Wind Farms MOG 2

Technical workshop

12.12.2022 | Davy Verwilghen, Tom Trappeniers, Damien Rietjens

Answers to key technical questions from stakeholders feedback

350MW building block

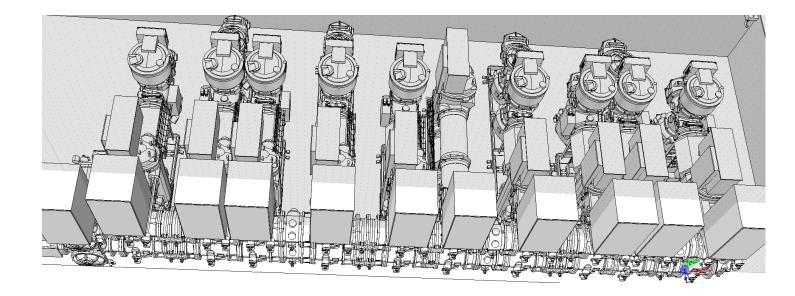
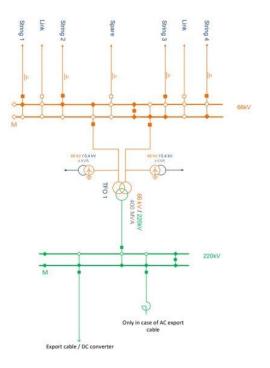
Stakeholders asks if spare bays will be foreseen to obtain flexibility

- In the inter-array cable design, Elia provides 4 connections of 90MW each (350MW per transformer)
- Elia designs 10 spare bays for max. 3,5GW Offshore Wind
 - 5 bays for OWF optimisation or OWF curative interventions.
 - 5 bays for future connections or TSO curative interventions.

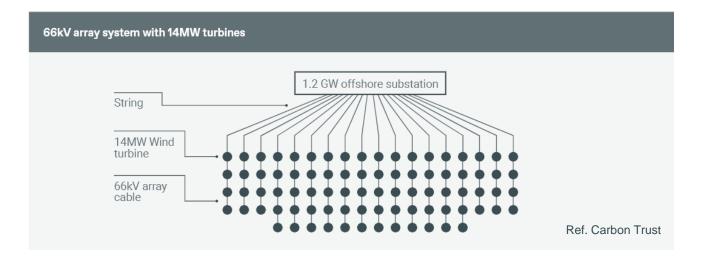
Several stakeholders respond about the looping of inter-array cables (i.e. connecting two strings at the end)

- The looping of strings has a strong link with the business case of the Wind Farms
- Elia concludes to keep this option available
- The fixed requirement from Elia is that the loop cannot connect on the busbar 66kV
- Looping of inter-array cables stays available for auxiliary services

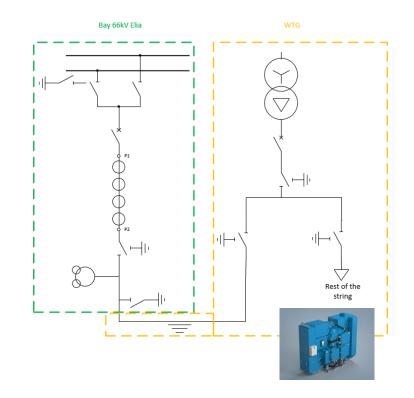
Several stakeholders respond about the Elia proposal to install a circuit breaker on the first wind turbine

- Elia has received 6 constructive responses with a clear pushback on installing a circuit breaker and/or voltage transformers on the first wind turbine
- Elia has investigated the option of the circuit breaker and detects clear opportunities to achieve operational independence between the OWF and Elia during the operational phase
- The feedback remains that an extra circuit breaker is an interesting idea, nonetheless will bring extra complexity and costs to the Wind Farms. The circuit breaker will not be included on the first wind turbine and in the further design
- Correspondingly, Elia will require all switch (disconnector and earthing) positions.
- Elia will provide the switching procedures during detailed design

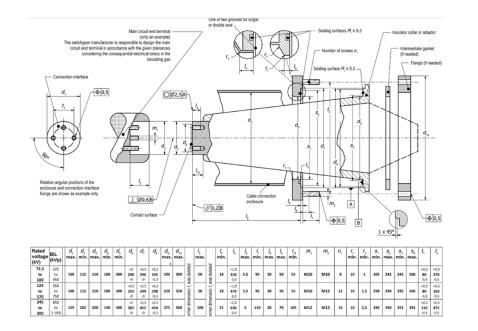
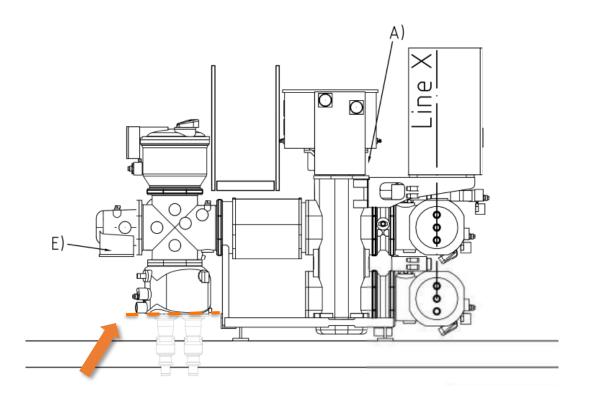
Questions for the cable interface and property borders

- Property and maintenance border remains at GIS cable compartment, in accordance with IEC62271-209
- Dry Type cable terminations Um: 72,5kV
